Subject: Duke Energy Corporation (DEC)
McGuire Nuclear Station Unit 2
Docket Number 50-370
Request for Additional Information (RAI); Procedure
for Straightening an Irradiated Fuel Rod (TAC NO.
MB7536)

Reference: (1) DEC letter to NRC, dated January 31, 2003 and (2)
NRC letter to DEC, dated April 4, 2003

ATTACHMENT 1

Figure 1 - Bent Rod Configuration at McGuire Unit 2

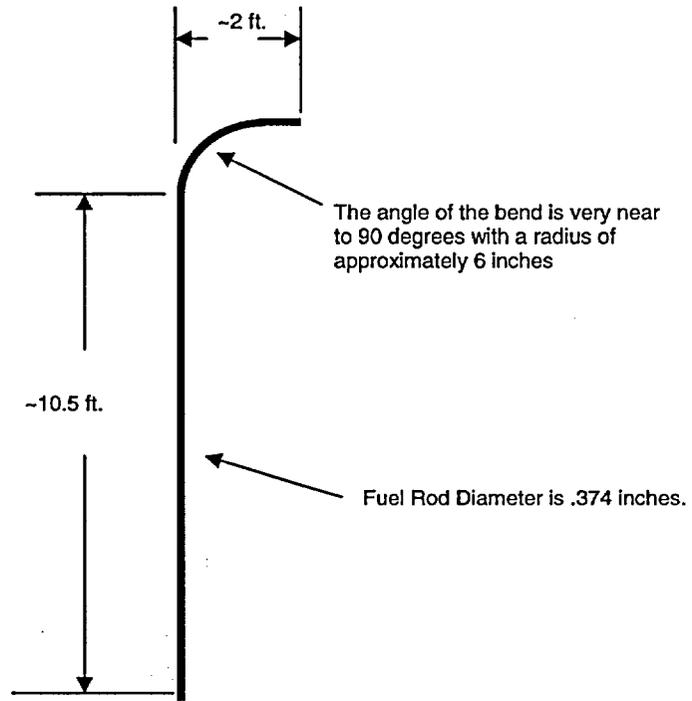
Provide a detailed description of the current state of the fuel rod. Describe the amount of damage the fuel rod previously incurred including the following: 1) the angle of the bend, 2) the axial location of the bend, 3) any measured or calculated thinning of the cladding due to the bend, and 4) any other pertinent information which classifies the extent of damage.

Figure 1 provides a schematic of the current profile of the bent rod. The angle of bend of the fuel rod is approximately 90 degrees with a bend radius of ~6 inches. The upper portion of the rod is approximately 24 inches with the lower section being about 126 inches.

Thinning of the cladding due to the bend is determined to be very minimal due to the internal support provided by the fuel pellets. In addition, the bend radius has no noticeable "crimps" or discontinuities. As reported in the licensing submittal, the bent fuel rod has experienced one cycle of operation with a burnup of 20.46 GWD/MTU. Material properties of Zircaloy 4 fuel cladding change as a result of irradiation. These changes include an increase in the cladding yield and ultimate strength and a decrease in ductility. In addition, the cladding experiences oxidation and hydrogen pickup as a result of the reactor environment. These changes are noted in the response to question 3.
